Charleston Tree Experts Scope of Work Requested to provide an independent, objective opinion regarding: the health and structural stability of the subject trees impact of the proposed road construction Level 2: Basic Tree Risk Assessment (BTRA) Used to identify, analyze and evaluate tree risk

Comparison of Impacts Alternative Submission A & Concept B

Submission A

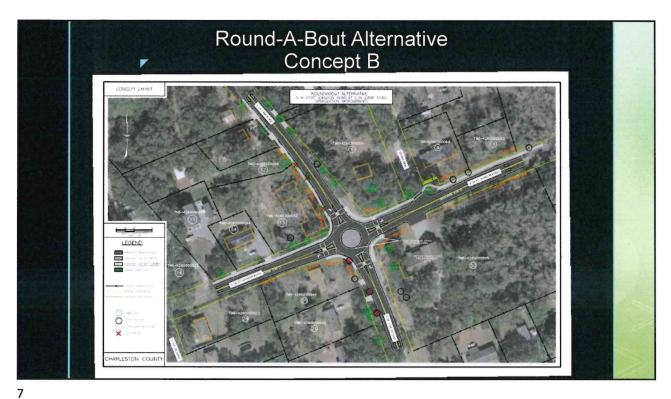
- 2 Properties before Intersection: Lots 5 & 13
- 2 Trees Require Removal, 3 Other Trees Impacted
- 3 Trees Retained
